AN1004 APPLICATION NOTE

WRITE PROTECT FUNCTION for 2Mb and 4Mb BOOT BLOCK FLASH MEMORIES

Figure 1. 2Mb (x8,x16) TSOP Pin Connections

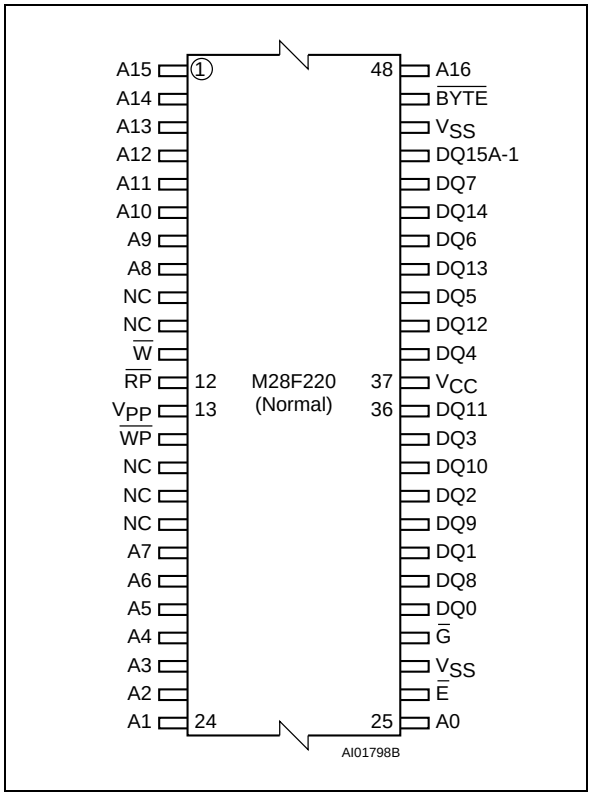
On TSOP40 package the $\overline{WP}$ is located on pin 12; on SO44 it is located on pin 2; on TSOP48 it is located on pin 14. The new products pinouts are described in the Figures 1 to 6.
